**ATTACHMENT 32 – COPY OF MINUTES OF MEETINGS, EMAILS AND
HANDWRITTEN NOTES FROM JULY 24, 2006 THROUGH MAY 2007 AS IT
RELATES TO PROPOSAL FOR STEEL PLATING OF ALL 52 FRACTURE
CRITICAL TRUSS MEMBERS**

Subject: Br. 9340 TH 35W over the Mississippi River investment strategy

Figure 1: Deck Truss Framing Plan and Elevation from Original Contract Plans
(Highlighted Members are Identified Fracture Critical Members)

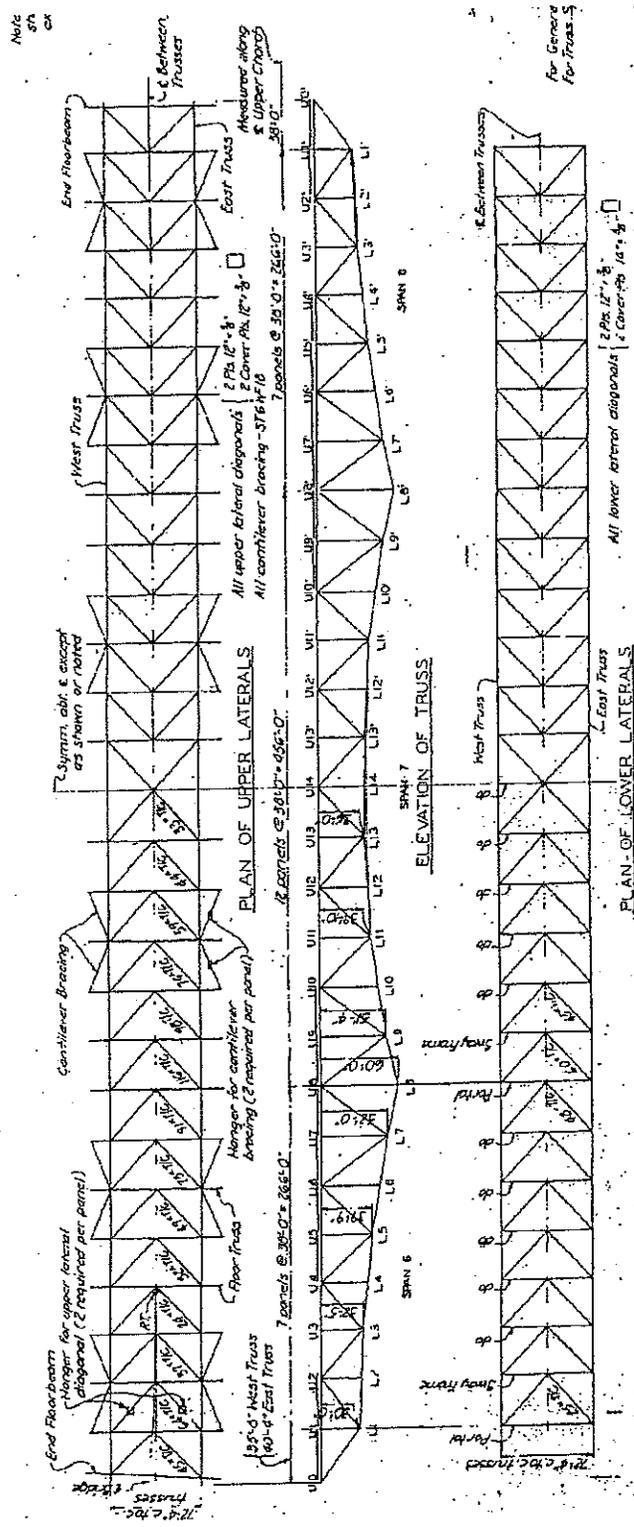
The following table lists the identified 13 fracture critical truss members on one half of each truss. Due to the double symmetry of the deck truss, there are a total of 52 fracture critical main truss members on the bridge structure. Figure 1 shows all the fracture critical members on one truss, or 26 members. These include the corresponding chord members on the opposing side of the zero-force vertical from the fracture critical members identified by the redundancy analysis.

The table also summarizes AASHTO criteria for infinite fatigue life check in accordance with the Fatigue Guide Specifications and the LRFR Manual using the fatigue truck method. The Fatigue Guide Specifications is more conservative than the LRFR Manual in that it applies a 1.75 reliability factor (vs. 1.0 in LRFR) to the calculated stress range due to the fatigue truck for fracture critical members and uses an infinite fatigue life limiting stress range of 0.367 times (vs. 0.5 times in LRFR) the constant amplitude fatigue threshold developed from fatigue tests. As shown in the table, all members satisfy the LRFR requirements for infinite fatigue life although the first six members fail to satisfy the Fatigue Guide Specifications for the Category E fatigue detail (U1-U2 is included in this group because of its counterpart U0-U1).

The fracture critical members can be divided into two general groups: (1) relatively more fatigue sensitive members (L1-L2, L2-L3, U0-U1, U1-U2, U4-U5, and U5-U6), these members are subject to higher fatigue load stress ranges, not satisfying the Fatigue Guide Specifications' infinite fatigue life check for Category E, but are subjected to lower total stresses and have thinner web plates that are more forgiving for brittle fracture; and (2) relatively more fracture sensitive members (L11-L12, L12-L13, L13-L14, U6-U7, U7-U8, U8-U9, and U9-U10), these members have larger cross sections and are subject to very low fatigue load stress ranges, satisfying all AASHTO infinite fatigue life checks for Category E, but are subjected to higher total stresses and have thicker web plates that do not tolerate the existence of through-thickness cracks before the occurrence of brittle fracture.

- (1) Steel plating of all 52 fracture critical truss members. This approach will provide member redundancy to each of the identified fracture critical members via additional plates bolted to the existing webs. The critical issue of this approach is to ensure that no new defects

Figure 1-1. Bridge 9340 General Plan and Elevation from Original Contract Plan

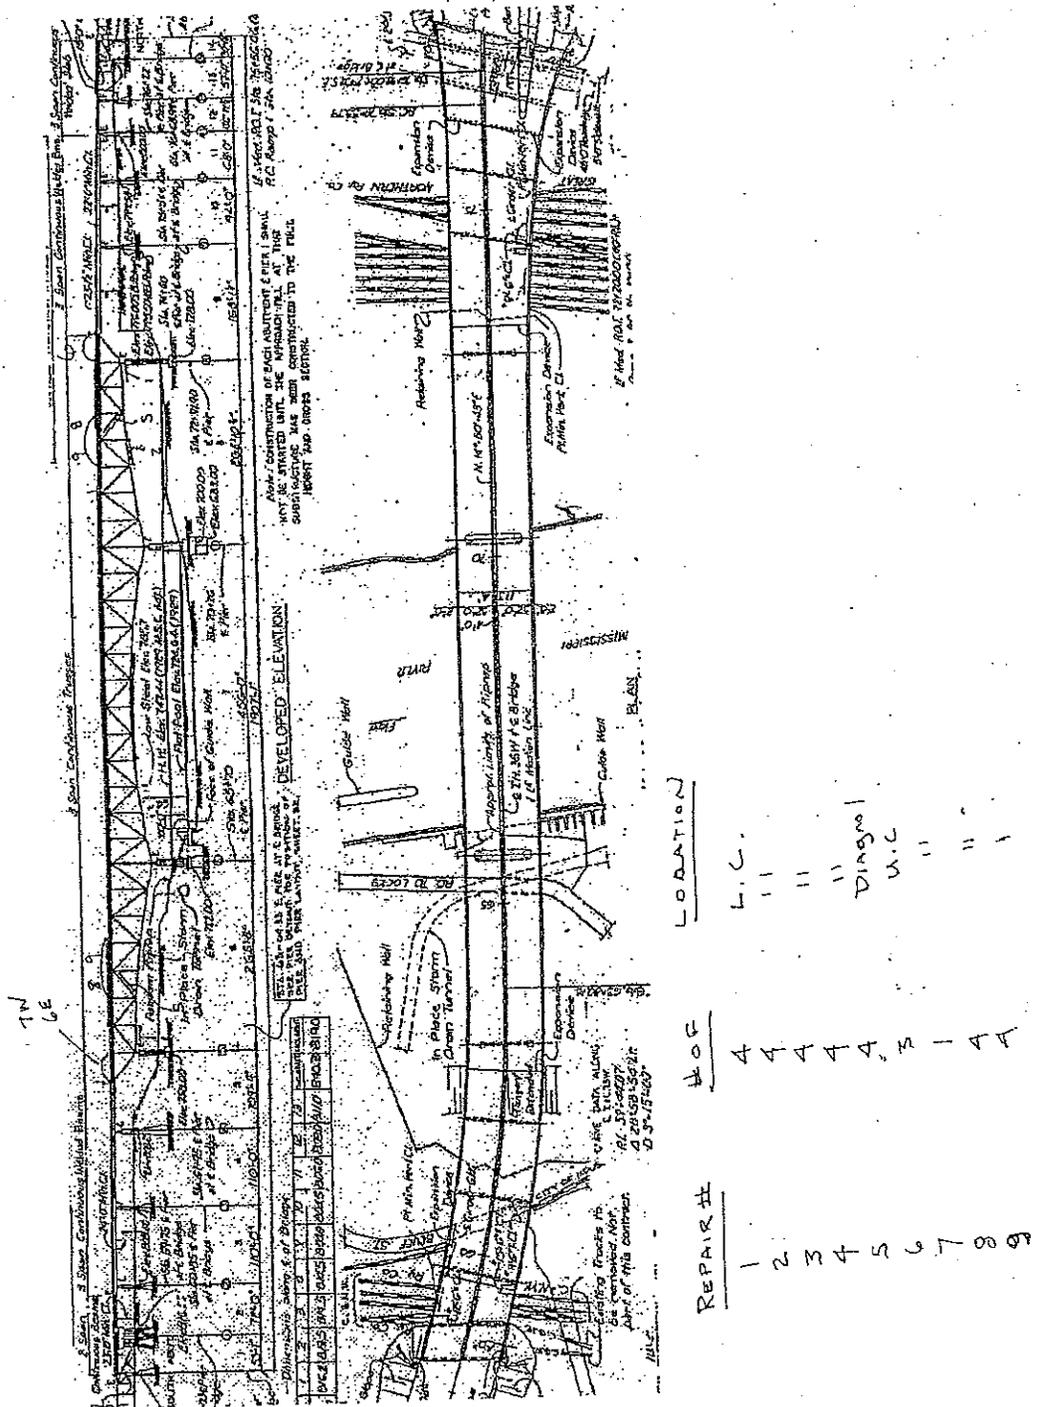
Tim, the scan of the bridge GPE sheet does not highlight with color the members we are planning to work on. Note that the members in the end spans of the truss are circled or numbered. In mid span of the main span you'll note about 4 bottom chord members have been thickened. They also will be worked on. In addition, there may be some members in the top chord located directly over the pier that the consultant is considering adding.

The contractors may also like to see a sample cross section of the repair. I have attached one generic cross section. Some of the plates will be larger, but the concept will be similar. It also may be good to clarify that in the pdf file you sent with the first message that the darkened areas of the lower chord of the center of the bridge are also areas to be repaired, even though they do not have a corresponding number on that sheet.

Figure 1: Deck Truss Framing Plan and Elevation from Original Contract Plans
(Highlighted Members are Identified Fracture Critical Members)

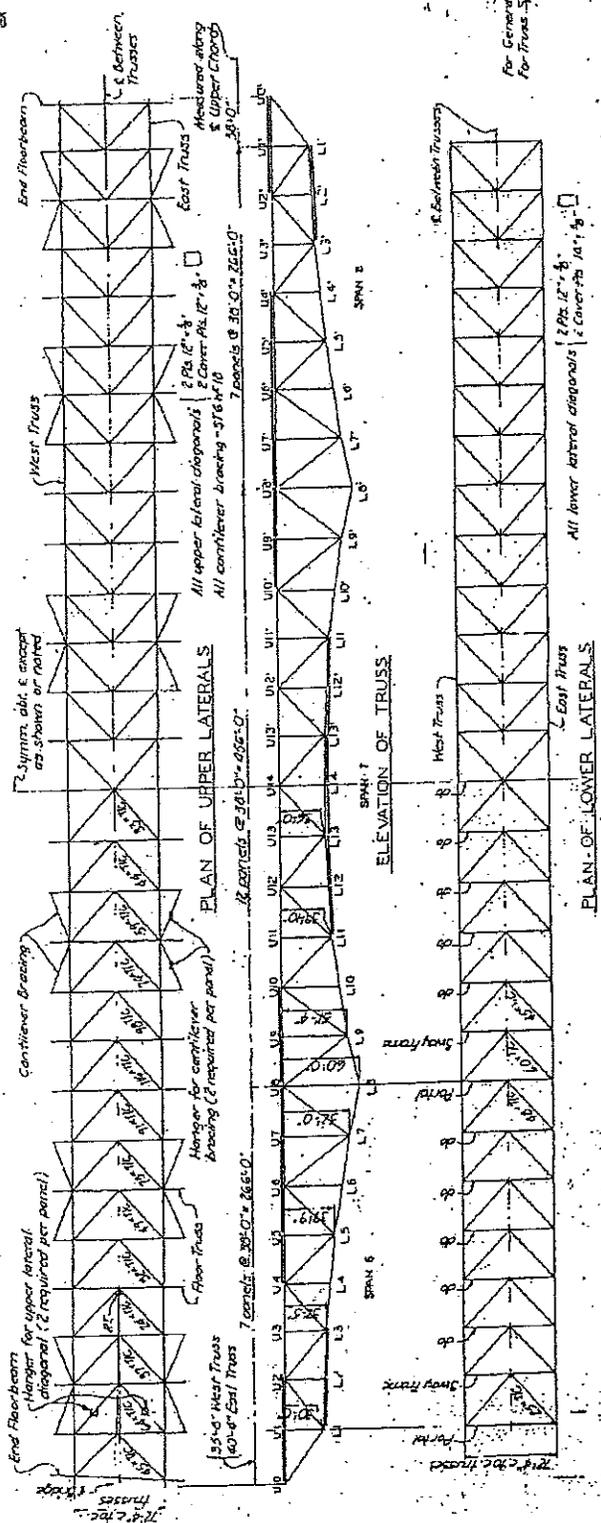
The following table lists the identified 13 fracture critical truss members on one half of each truss. Due to the double symmetry of the deck truss, there are a total of 52 fracture critical main truss members on the bridge structure. Figure 1 shows all the fracture critical members on one truss, or 26 members. These include the corresponding chord members on the opposing side of the zero-force vertical from the fracture critical members identified by the redundancy analysis.

The table also summarizes AASHTO criteria for infinite fatigue life check in accordance with the Fatigue Guide Specifications and the LRFR Manual using the fatigue truck method. The Fatigue Guide Specifications is more conservative than the LRFR Manual in that it applies a 1.75 reliability factor (vs. 1.0 in LRFR) to the calculated stress range due to the fatigue truck for fracture critical members and uses an infinite fatigue life limiting stress range of 0.367 times (vs. 0.5 times in LRFR) the constant amplitude fatigue threshold developed from fatigue tests. As shown in the table, all members satisfy the LRFR requirements for infinite fatigue life although the first six members fail to satisfy the Fatigue Guide Specifications for the Category E fatigue detail (U1-U2 is included in this group because of its counterpart U0-U1).

note
STA
EX

The fracture critical members can be divided into two general groups: (1) relatively more fatigue sensitive members (L1-L2, L2-L3, U0-U1, U1-U2, U4-U5, and U5-U6), these members are subject to higher fatigue load stress ranges, not satisfying the Fatigue Guide Specifications' infinite fatigue life check for Category E, but are subjected to lower total stresses and have thinner web plates that are more forgiving for brittle fracture; and (2) relatively more fracture sensitive members (L11-L12, L12-L13, L13-L14, U6-U7, U7-U8, U8-U9, and U9-U10), these members have larger cross sections and are subject to very low fatigue load stress ranges, satisfying all AASHTO infinite fatigue life checks for Category E, but are subjected to higher total stresses and have thicker web plates that do not tolerate the existence of through-thickness cracks before the occurrence of brittle fracture.

- (1) Steel plating of all 52 fracture critical truss members. This approach will provide member redundancy to each of the identified fracture critical members via additional plates bolted to the existing webs. The critical issue of this approach is to ensure that no new defects
